Drainage Statement

Planning Reference: Havant Borough Council APP/17/01036
Site Address: Land to rear of 60 Fir Copse Road, Waterlooville PO7 5HZ

This statement has been written to address concerns raised by Havant Borough Council and the Environment Agency with respect to the development proposals submitted under the above planning application.

Figure 2: Possible NPHS Open Channel Detail

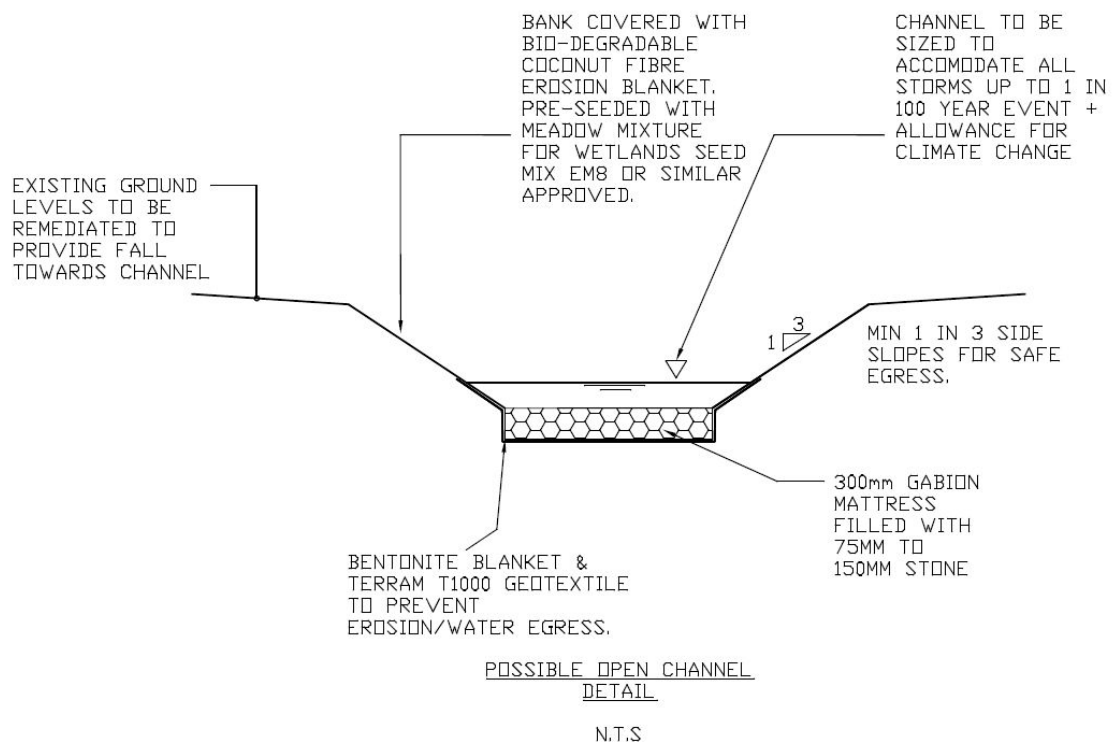
The proposed development is unacceptable because it involves building over or very close to a culverted main river watercourse (North Purbrook Heath Stream) and would be unlikely to receive an Environment Agency permit for the works for the following reasons:

In its current form the proposed works would not be granted a permit due to an unacceptable risk to the culvert.

- It is therefore proposed that the culverted section of the NPHS running from the existing inlet headwall (located approximately adjacent to the rear gardens of Numbers 50 & 52 Fir Copse Road), up to the southern edge of Sandy Brow road, is replaced with an open channel.
- The new open channel would be sized to accommodate all flows up to and including the 1 in 100 year + Climate Change flood event and should drastically improve land drainage on site and for the surrounding properties.
- A possible detail for the new open channel is provided in Figure 2 below, subject to confirmation/acceptance from the Environment Agency.

Figure 3: Substation piled raft detail

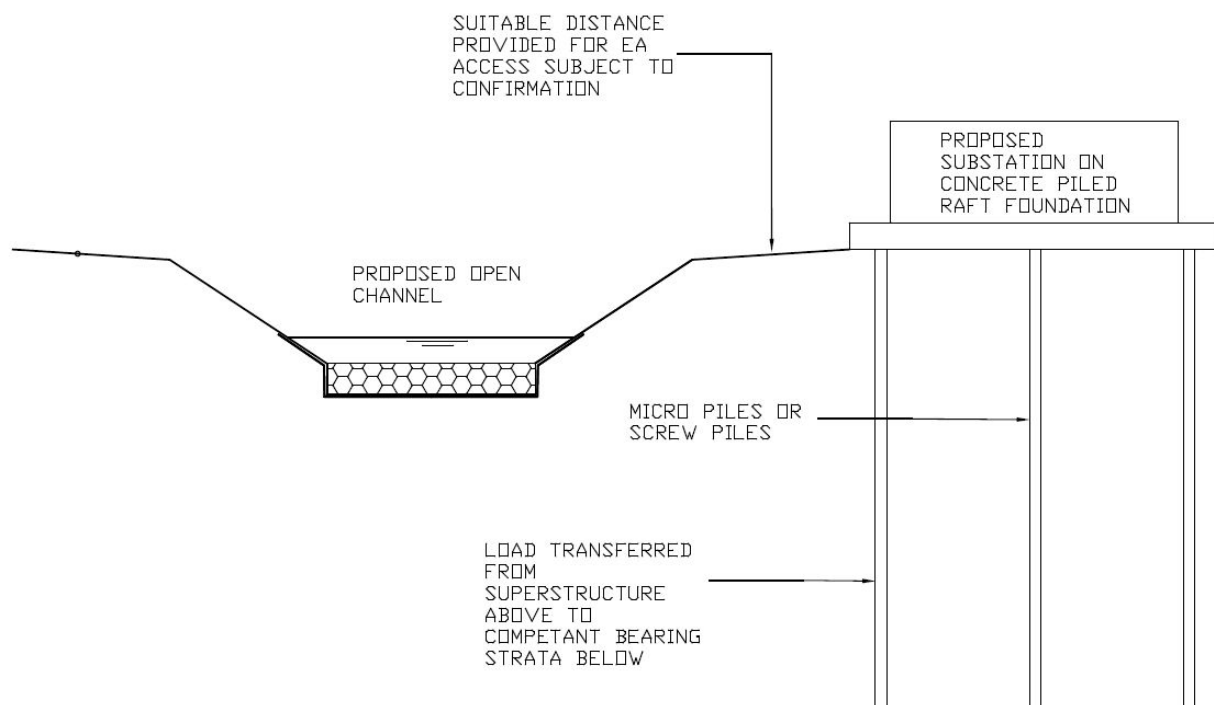
- Although the proposed siting of the residential property is not of concern the repositioned electricity substation is located over or very close to a culverted watercourse. No details have been provided on the construction and therefore an assessment of the potential impact upon the culvert and its structural integrity cannot be made.
- Building over or very close to a culvert can restrict access for essential maintenance purposes. The permanent retention of a continuous unobstructed area is an essential requirement for future maintenance and/or improvement works.

The Environment Agency recommends that the exact position of the culvert is determined and if the existing substation is to be re-positioned then a suitable distance is maintained from the culvert.

Furthermore, details of the construction and foundations should be provided together with confirmation that they will have no adverse impact upon the structural integrity of the culvert.

- The existing electricity substation within the curtilage of the site is to be repositioned to facilitate development.
- This provides the opportunity to erect a new substation on a localised piled foundation to ensure that there will be no adverse impact on the structural integrity of the new open channel section of the NPHS.
- The use of micro piles or screw piles would minimise any impact on the existing trees during installation and in service.
- It is intended that the route of the new open channel section of the NPHS replicates the route of the existing culvert as much as possible, but may be altered slightly if required to provide the EA with sufficient access for maintenance. Guidance will be sought from the EA on provision of appropriate access.
